**CITY OF  
PARRAMATTA**

## Report to Sydney Central City Planning Panel

<b>SWCCP reference</b>	2018SWC067
<b>DA No.</b>	DA/393/2015/A
<b>Date of receipt</b>	17 April 2018
<b>Proposal</b>	Section 4.55(1A) Modification to an education establishment
<b>Street address</b>	119 Rausch Street, TOONGABBIE NSW 2146
<b>Property Description</b>	Lot 111 DP 749237
<b>Applicant</b>	Reitsma Constructions
<b>Owner</b>	Campion Foundation Limited
<b>Submissions</b>	Three (3)
<b>List of All Relevant s79C(1)(a) Matters</b>	<ul style="list-style-type: none"><li>• Environmental Planning and Assessment Act and Regulations</li><li>• State Environmental Planning Policy No. 55</li><li>• State Environmental Planning Policy (Vegetation in non-rural areas) 2017</li><li>• State Environmental Planning Policy (Sydney Harbour Catchment) 2005</li><li>• State Environmental Planning Policy (State and Regional Development) 2011</li><li>• State Environmental Planning Policy (Infrastructure) 2007</li><li>• Parramatta Local Environmental Plan 2011</li></ul>

**Figure 4: Extract of proposed stormwater plan showing location of OSD.**

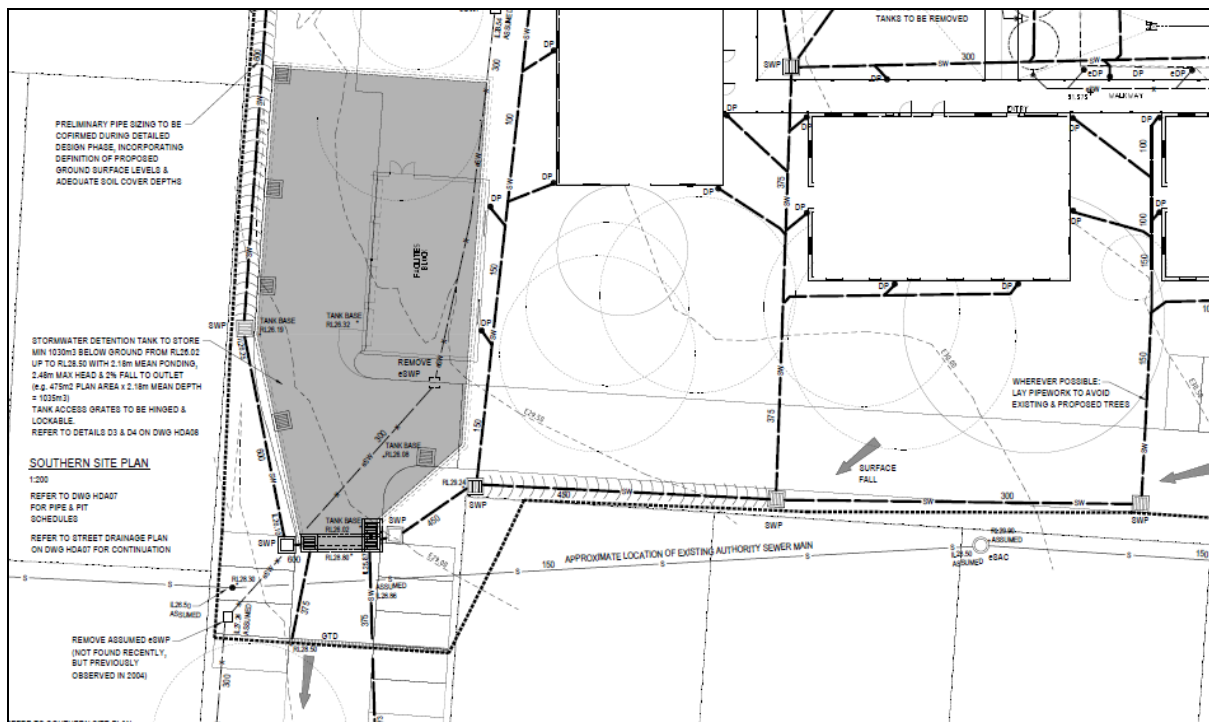
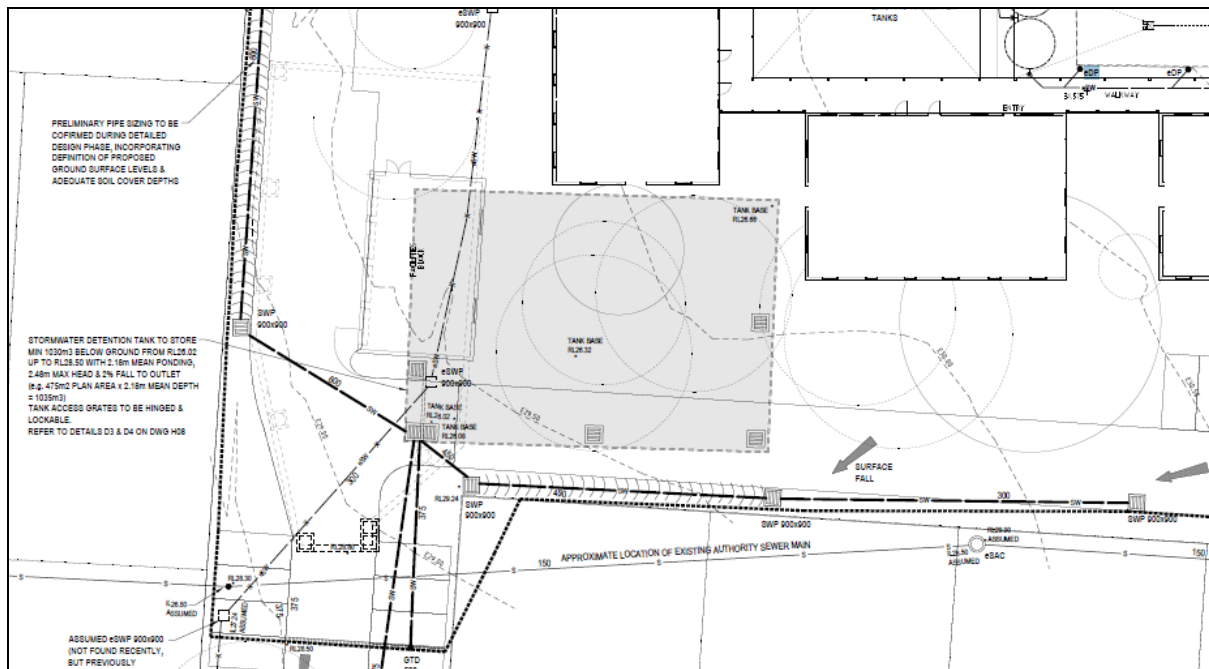
The proposal relates to the relocation of an approved on-site detention system only as follows:

The application includes the removal of three additional trees from the site.

The proposed modification does not alter the overall operation of the educational establishment and impacts on the stormwater drainage of the site only

The Parramatta Development Control Plan 2011 has been considered in the assessment of the proposal, in particular the management of stormwater and the removal of trees. In summary, the proposal continues to appropriately drain stormwater without further impacting on adjoining properties and the removal of trees is acceptable.
